RE: Solar Energy Storage Facility – Site B
Stormwater Permit/Site Plan Application
0 Murdock Avenue
Winchendon, Massachusetts

Hannigan Engineering, Inc is in receipt of peer review comments from Tighe and Bond in a letter dated May 11, 2023 relative to a Stormwater Permit Application & Site Plan Review for the construction of an Energy Storage Facility a 0 Murdock Avenue in Winchendon, Massachusetts. It should be noted that per a comment raised by a Planning Board member the datum of the site has been updated to reflect the NAVD1988 datum. We offer the following responses to their comments below.

Review Comments:

MassMapper

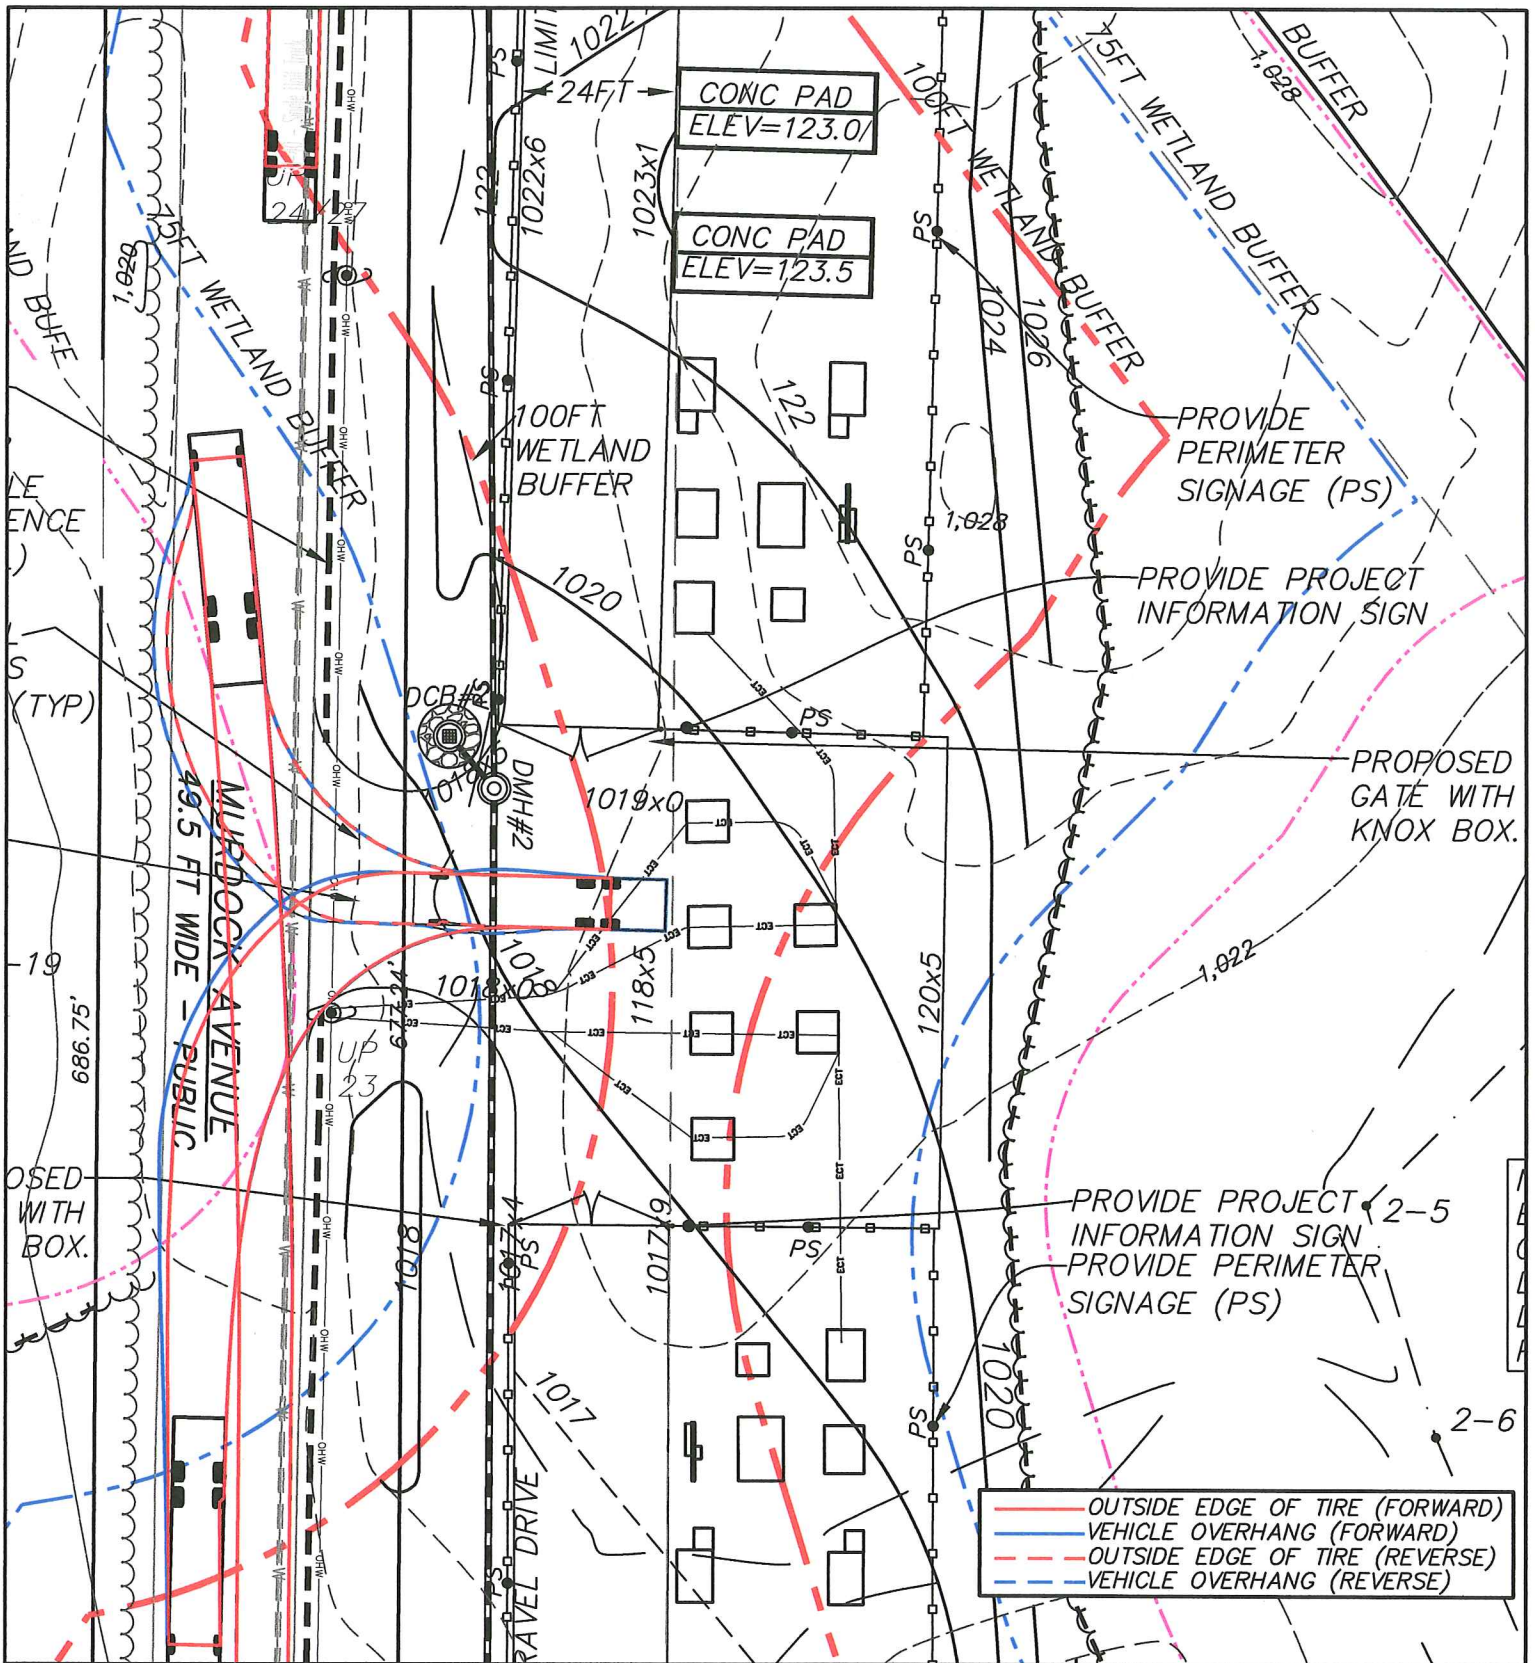
- Comment #20:** *Section 3.3.4(H) requires water balance calculations for sites all or partly within a Groundwater Protection Overlay District. The Consultant should confirm whether the site is within the Overlay District, and, if so, provide the necessary calculations*

- Response:** **This office has requested the Plan as reference within the Bylaw from the Town Clerk and at this time it has been unable to be located. As such a review of MassGIS “MassMapper” has revealed that there are no mapped aquifer areas located within the project scope. As such it is anticipated that the project is not subject to the Groundwater Protection Overlay District.**
